## ADDENDUM NO. 2

**TO: PLANS AND SPECIFICATIONS FOR STATE OF MISSOURI**

**State of Missouri St. Clair Readiness Center  
375 Commercial Avenue  
St. Clair Missouri 63077  
Project No. T2326-01**

**1 RESTROOM PLAN**  
1/4" = 1'-0"

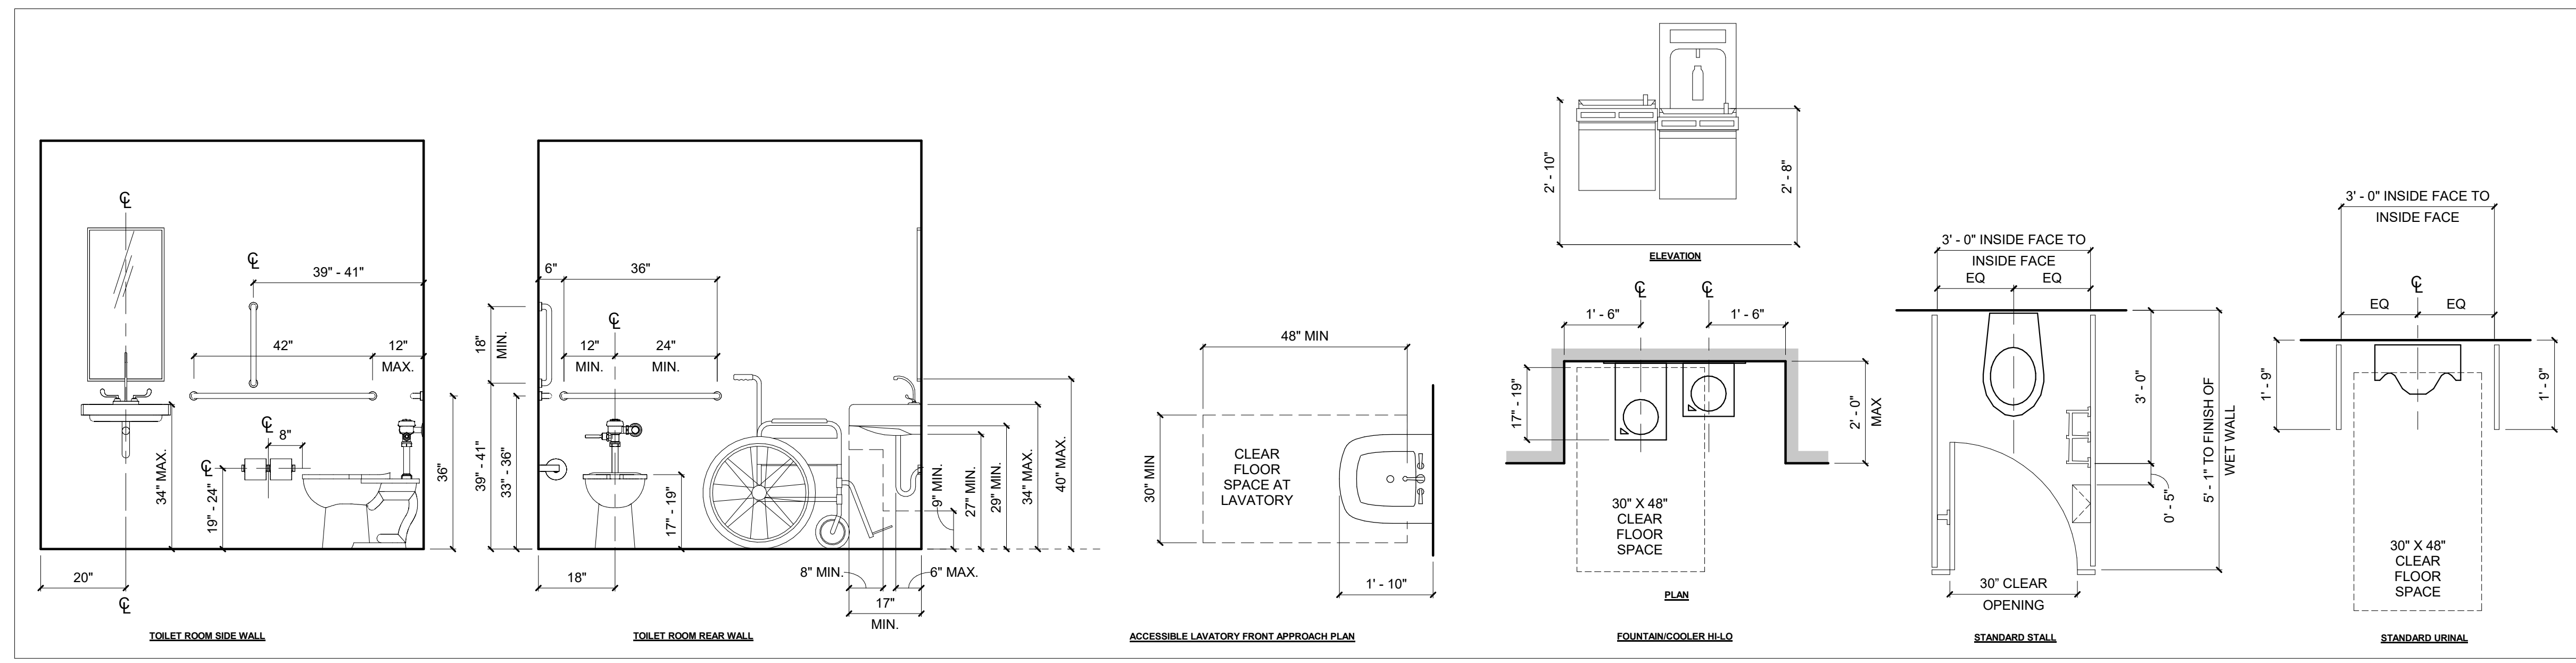
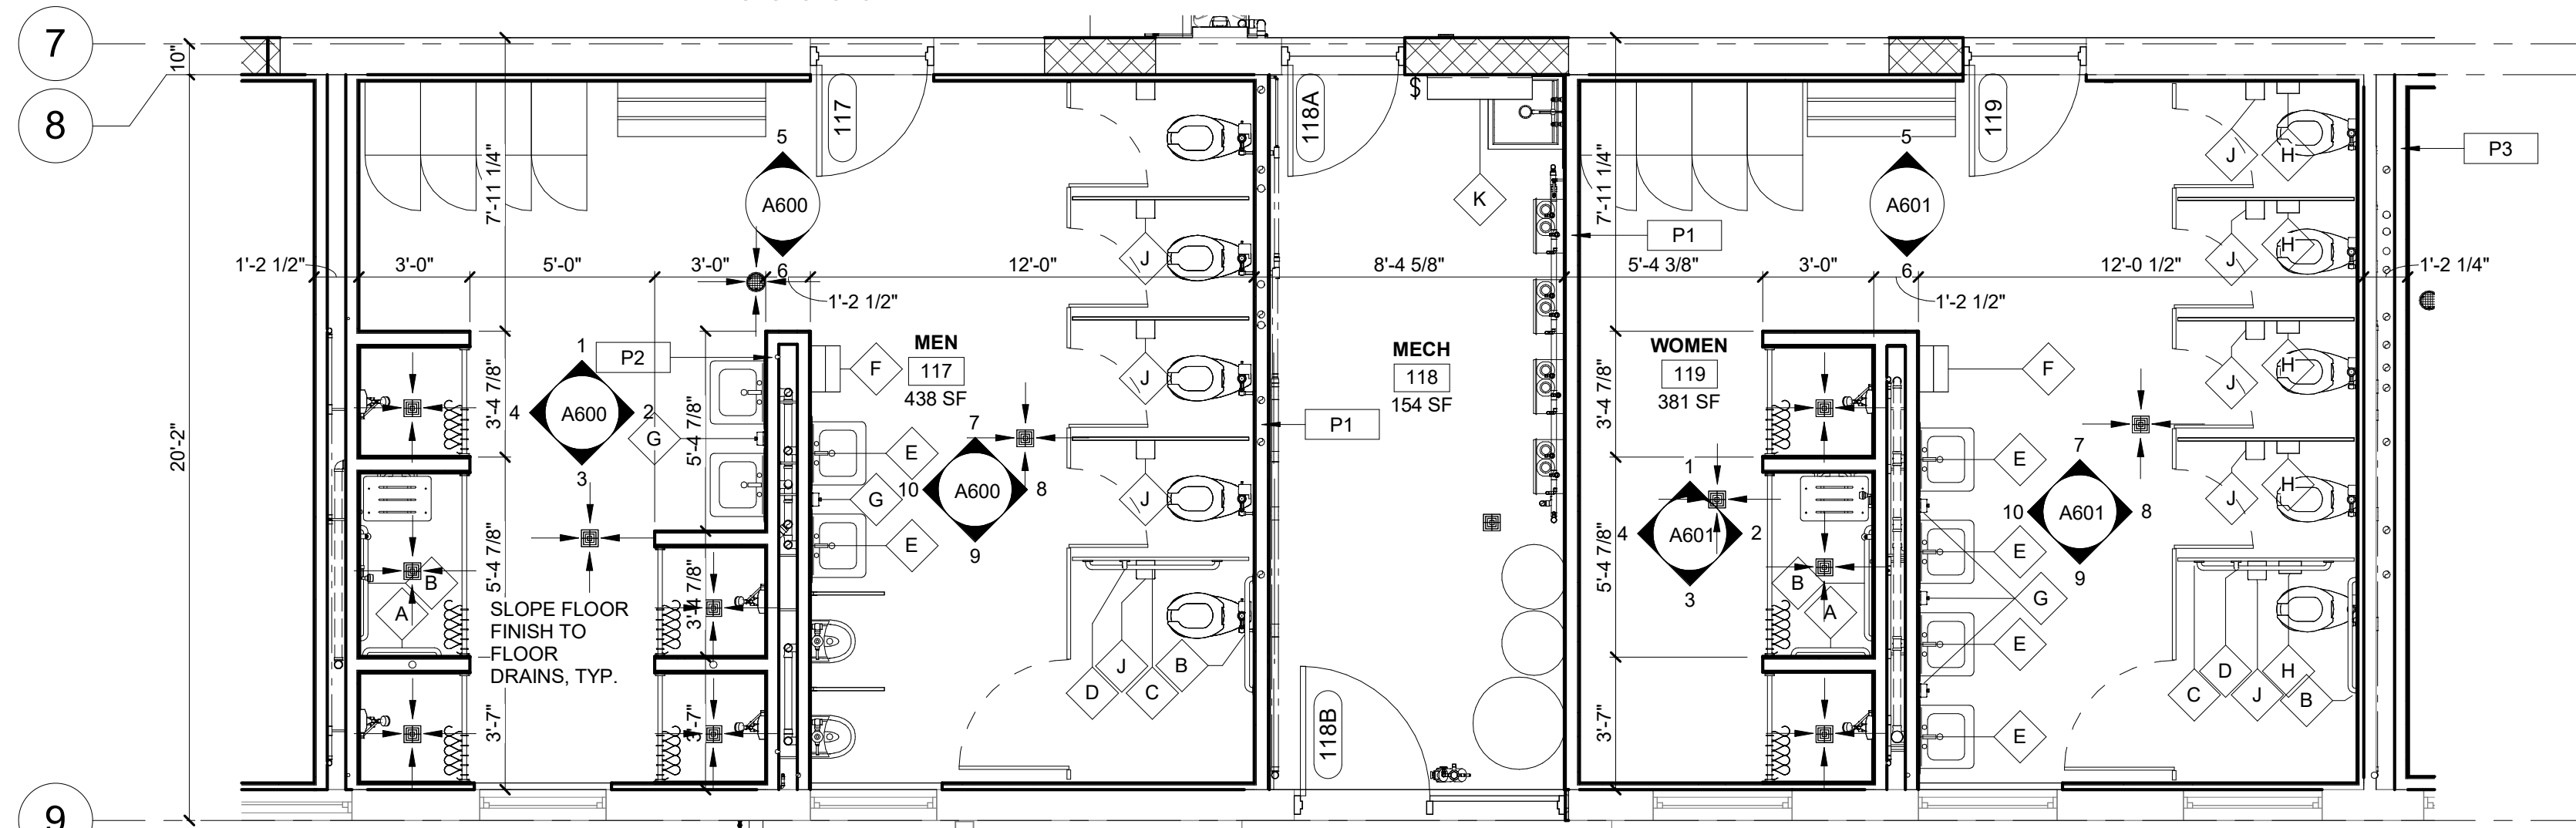
3. Drawing A100:
  - a. CHANGE Door 120A size.
4. Drawing A120:
  - a. Graphics changed from 2x4 to 2x2 ceiling tiles.
5. Drawing A140:
  - a. UPDATE Restroom accessories schedule, to clarify restroom accessories to be contractor furnished, contractor installed. The only items that will be owner furnished and contractor install will be the Paper Towel dispensers and soap dispensers

**1 ENLARGED KITCHEN PLAN**  
1/4" = 1'-0"

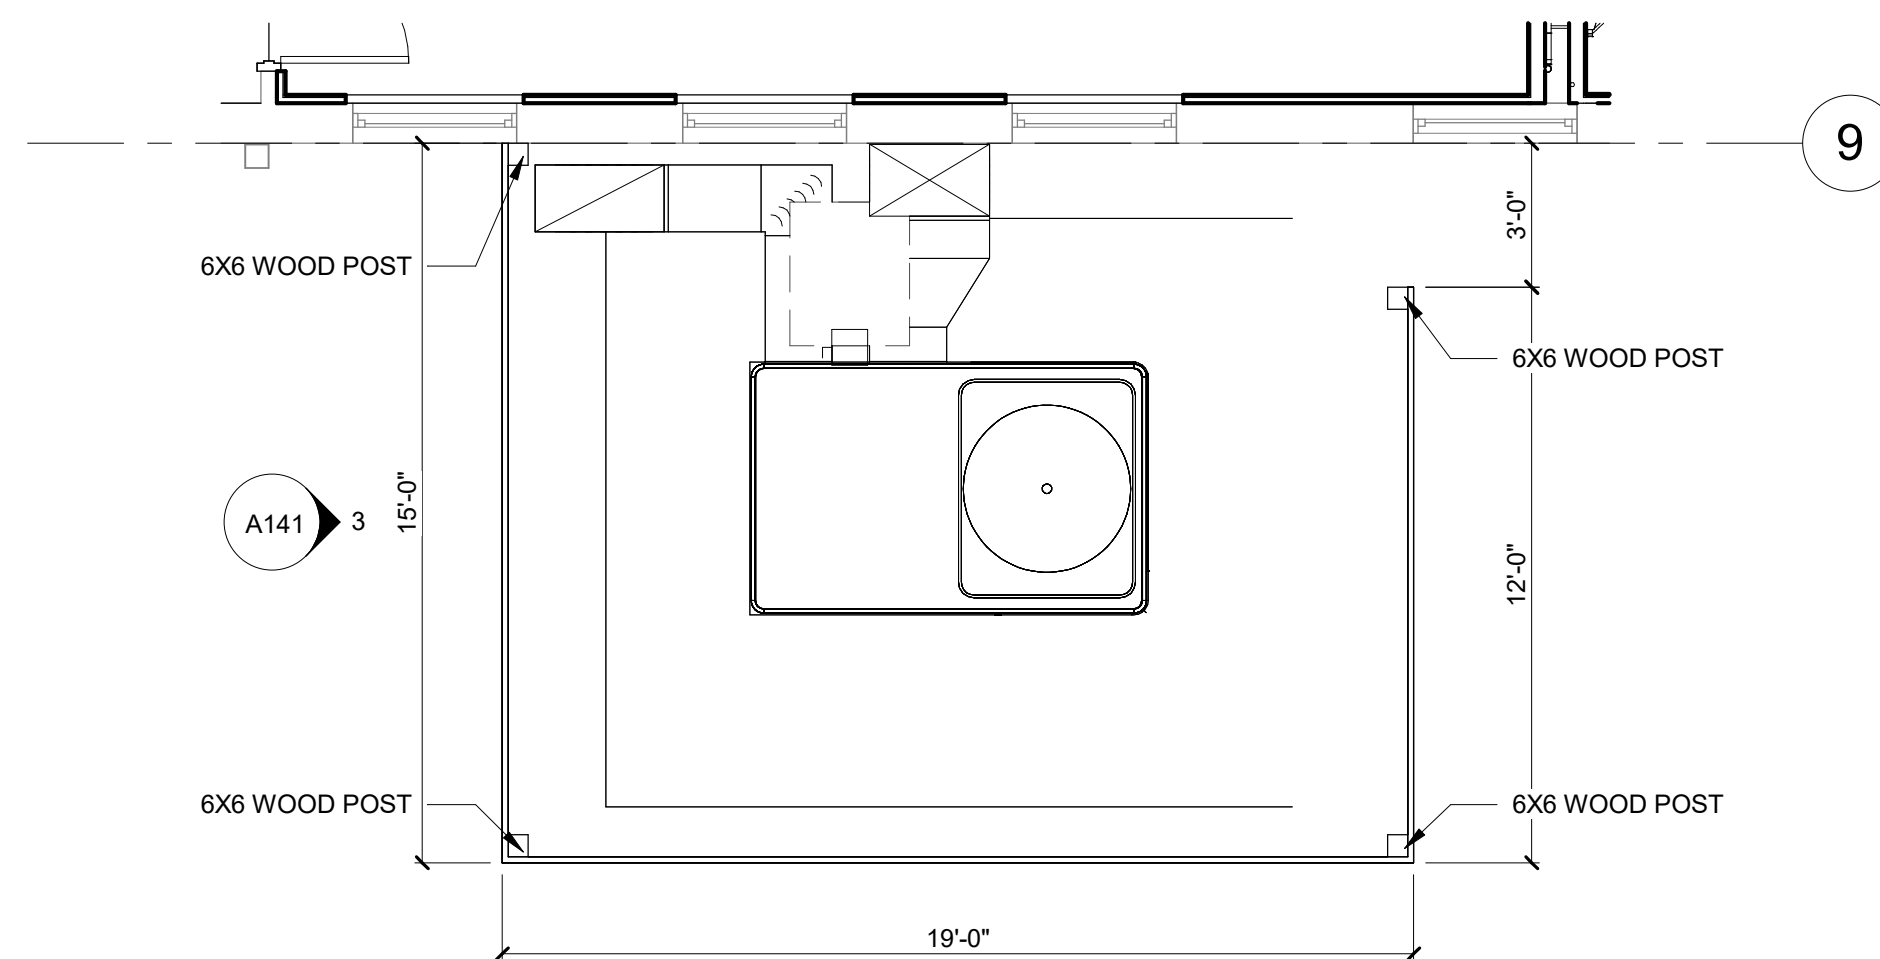
6. Drawing A141:
  - a. CHANGE Racks quantity to be 2 Racks instead of 1.
  - b. ADD Callout for the counter opening in the kitchen.
7. Drawing A200:
  - a. ADD Specifications note for the exterior ladder access signs.

**A201**

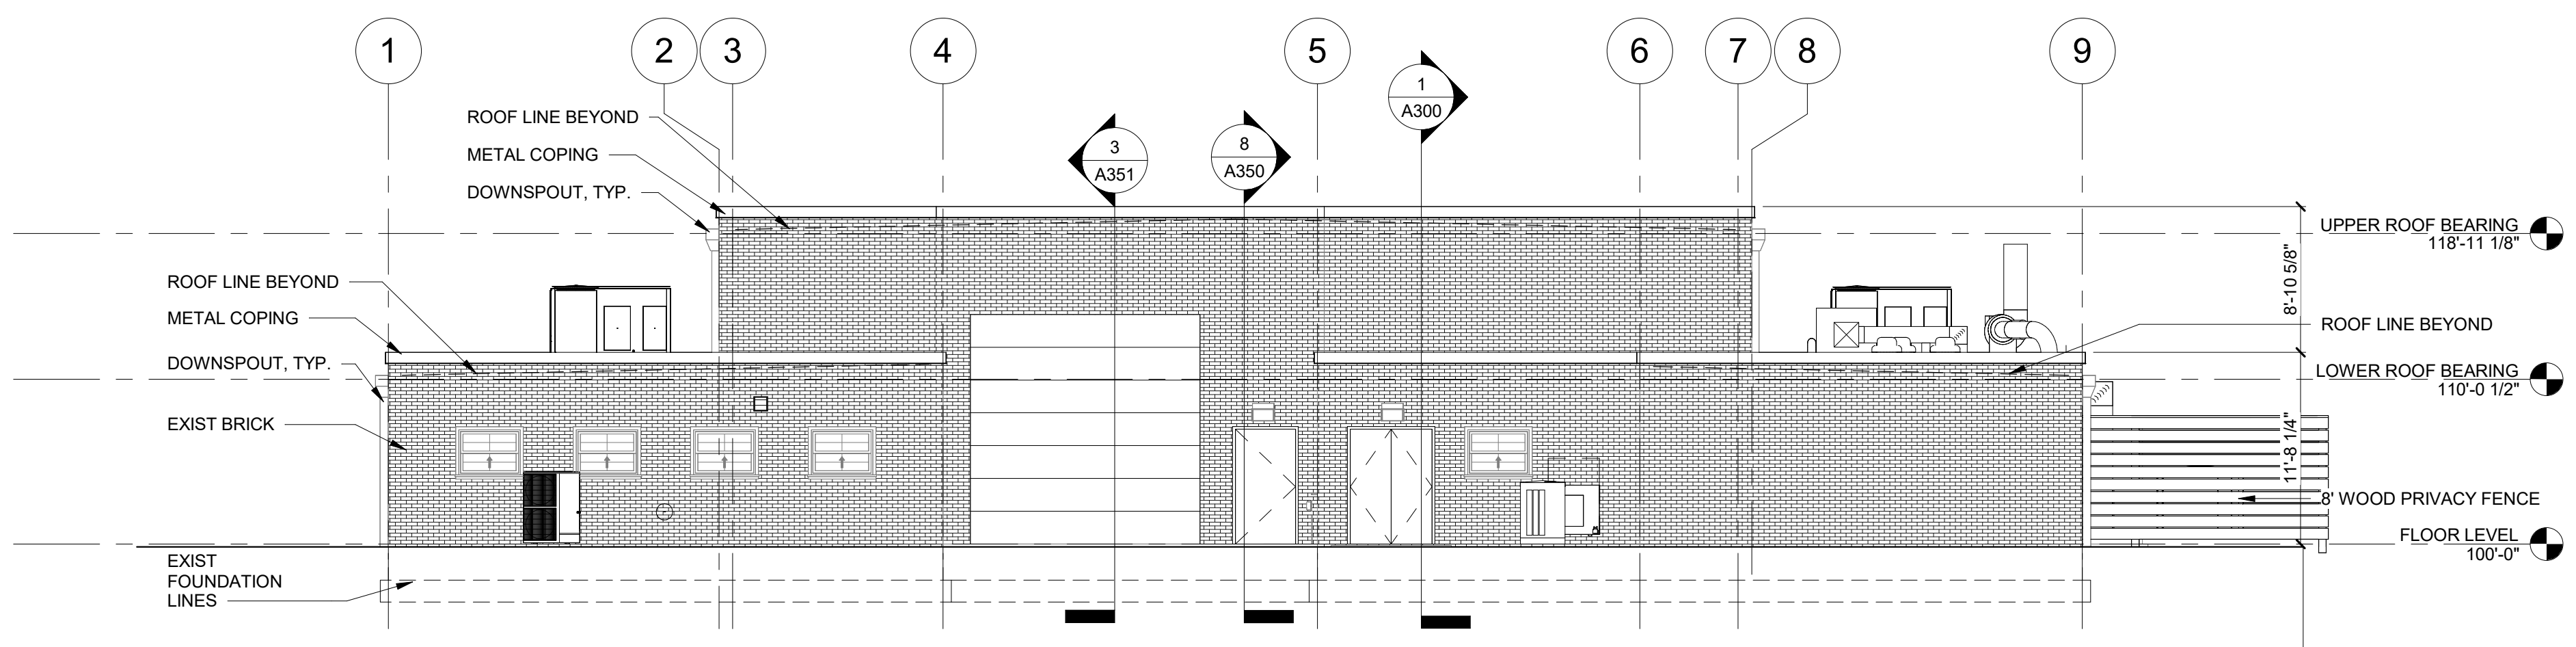
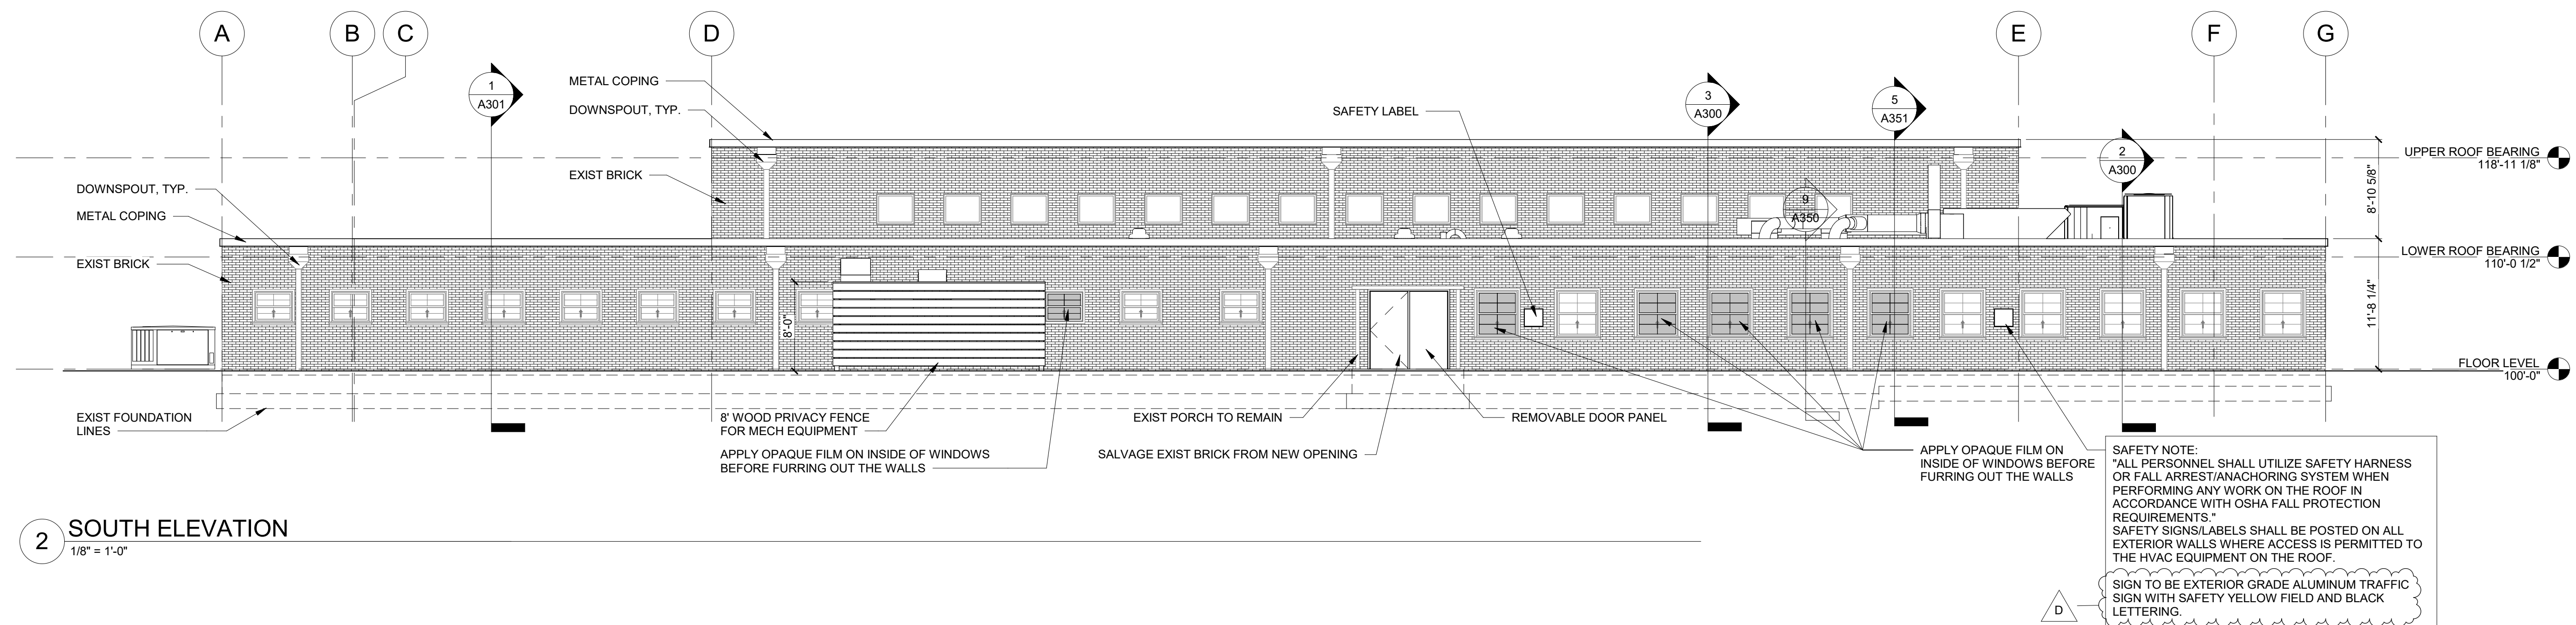
8. Drawing A201:
  - a. ADD Specifications note for the exterior ladder access signs
9. Drawing A351:
  - a. ADD Structural detail on wall section 5 for the counter opening in the kitchen.
